TITLE XD10P Ground Fix		NUMBER TN-F441	REV C	PAGE 1 of 2
	DEPARTMENT Engineering	CREATED BY: K. Hultgren	EFFECTIVE DATE 4/05/06	APPROVED BY:

Figure 1

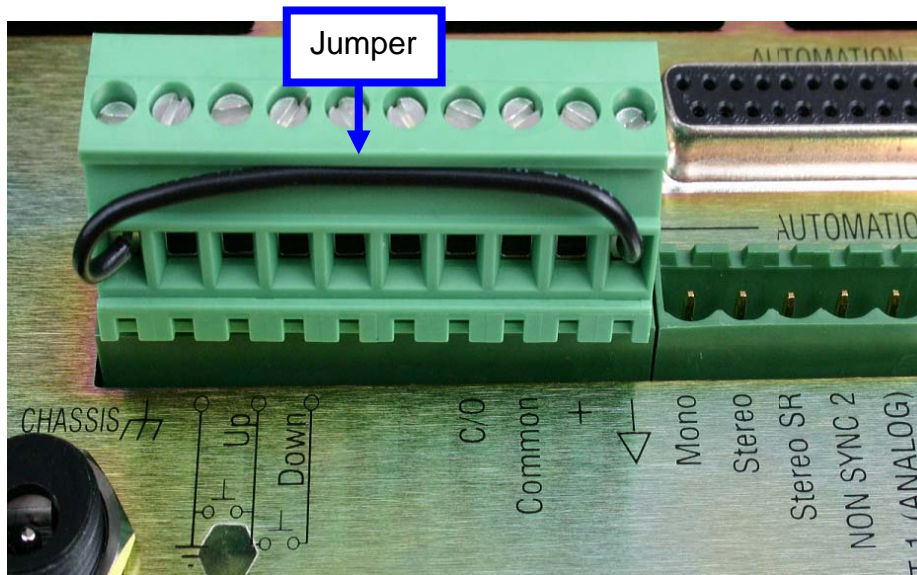
XD10P units produced until April 2006 have an open ground inside the unit. This open ground can produce noise in some installations. In most cases, simply adding a jumper between chassis ground and analog ground on a rear panel Phoenix connector will fix the problem. See Figure 1.

Units produced after April 2006 and after will have the grounds tied together inside the unit. Units produced before April 2006 that are having noise issues, will require a jumper added to the Phoenix connector, as shown below.

Some XD10P shipments in March – April 2006 will come with jumpers pre-installed on Phoenix connectors. Care should be taken when installing the Phoenix connectors to the back of the unit. Please make sure to put the Phoenix connector with the jumper on the left header. Putting the connector on the right header will lock the XD10P into the SR mode.

Figure 2

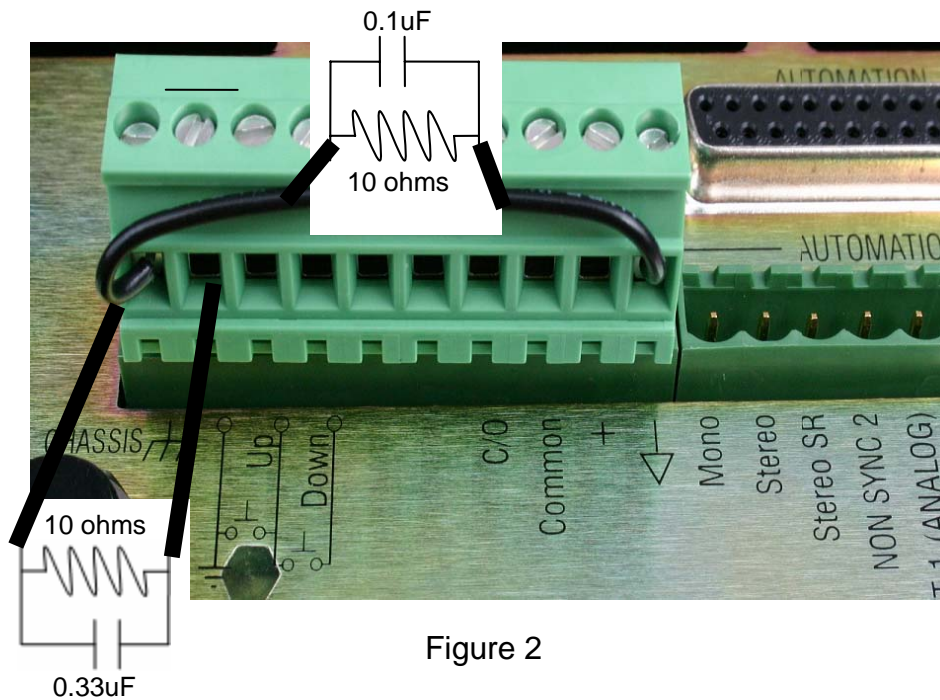
If the noise persists after adding the jumper between grounds, you must add two RC circuits between the grounds as shown in Figure 2.

- Add a 0.1uF capacitor in parallel with a 10 ohm ¼ watt resistor between chassis and digital grounds (adjacent to each other) on the Phoenix connector.
- Add a 0.33uF capacitor in parallel with a 10 ohm ¼ watt resistor between chassis and analog ground on the Phoenix connector.
